UNITED STATES PATENT AND TRADEMARK OFFICE

APPLICATION NO.	FILING DATE	FIRST NAMED INVENTOR	ATTORNEY DOCKET NO.	CONFIRMATION NO.
10/668,445	09/23/2003	Joseph A. Marino	C516.12-0014	2339
164	7590	05/04/2005	EXAMINER	
KINNEY & LANGE, P.A. THE KINNEY & LANGE BUILDING 312 SOUTH THIRD STREET MINNEAPOLIS, MN 55415-1002			PRONE, CHRISTOPHER D	
			ART UNIT	PAPER NUMBER
			3738

Office Action Summary

DETAILED ACTION

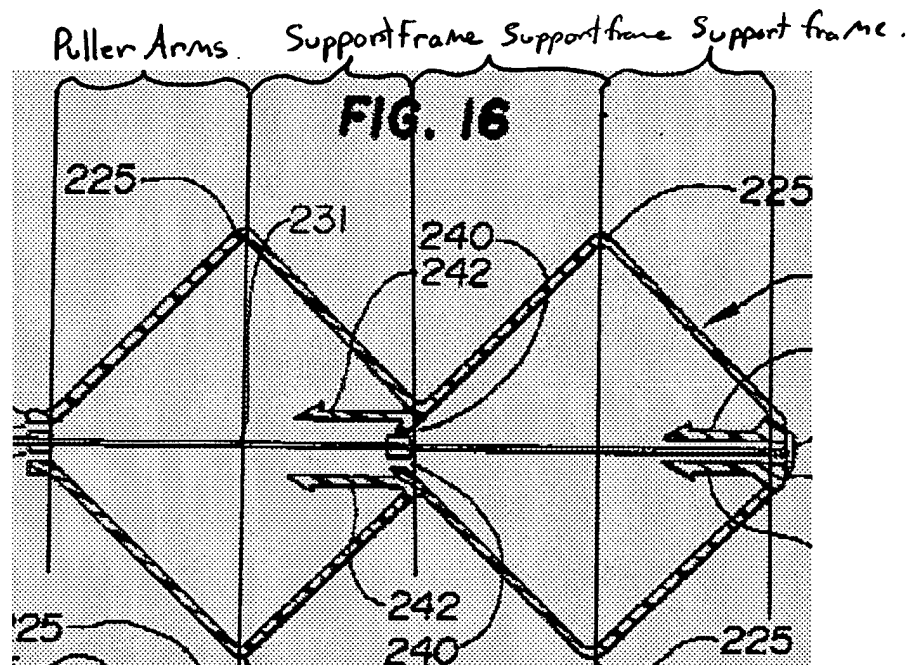
In regards to claims 1, 8, 17, 24, 31, and 38 Huebsch discloses the same invention being an automatic loading mechanism for an occlusion device comprising: a

occluding body (10) with fixed and floating center posts (232) (216), a plurality of puller arms (222), first and second support frames (222) comprising elastic shape memory fixation devices described in column 3 on lines 64-67 of Huebsch, right and left sheets described in column 4 on lines 25-26 of Huebsch, and right and left support hoops (216) (218) shown in figures 1-25 of Huebsch. See figure below for more detailed description of the puller arms and support frames.

In reference to claim 15 Huebsch discloses the same invention wherein the support frames each comprise a wire hoop (216) (218) and a plurality of support arms (222) shown in figures 1-25 of Huebsch and in the figure above.
